Nutter Park Playground Equipment Installation

4/28/2022 Bid Addendum

Nutter Park Playground Project 2022

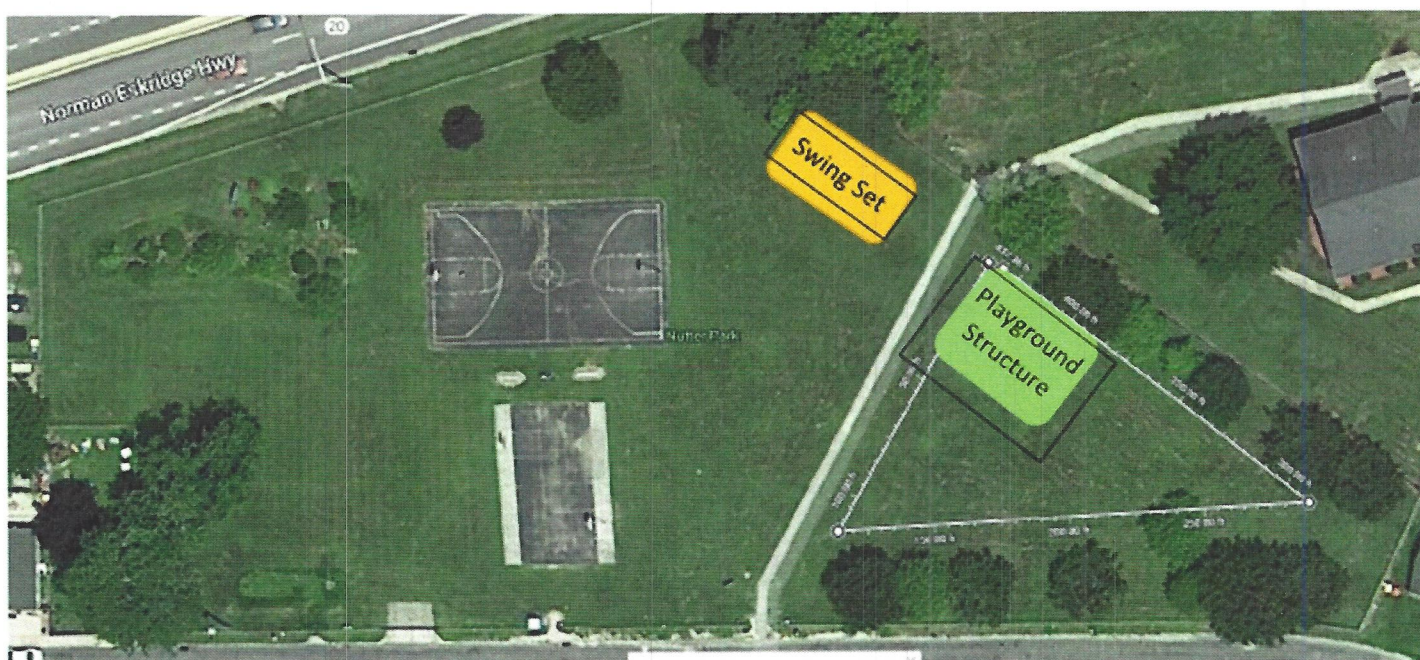
The photo above shows the current swing set structure that was installed in 2018 – on the far side of the playground is a sidewalk and the placement of the proposed playground structure would be located on the other side of the sidewalk.

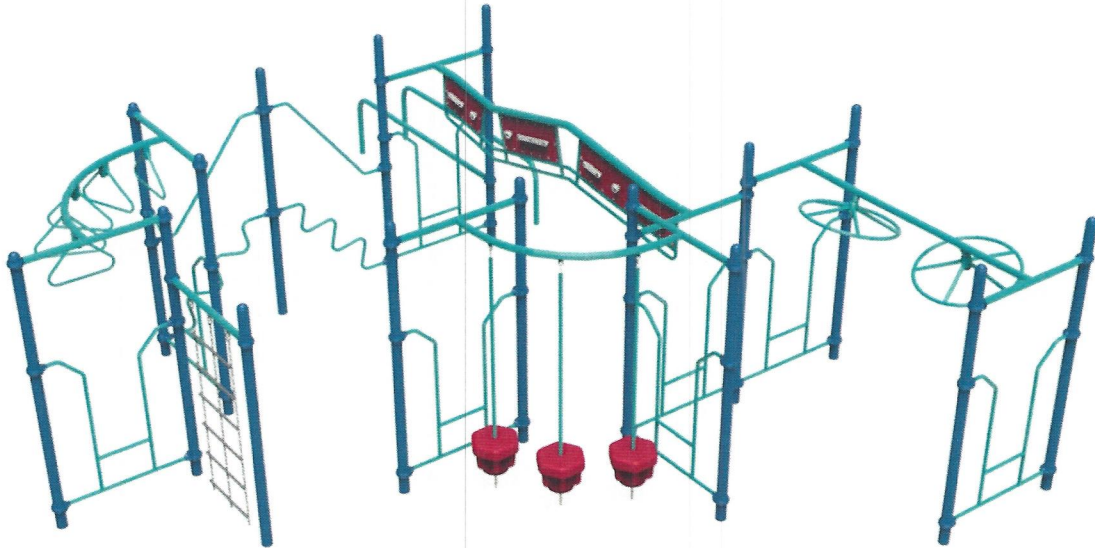
The photo above is an aerial view of the proposed location for the playground structure. The white triangle shows there is about 432 lineal feet (or about 8,000sqft) of space in the area.
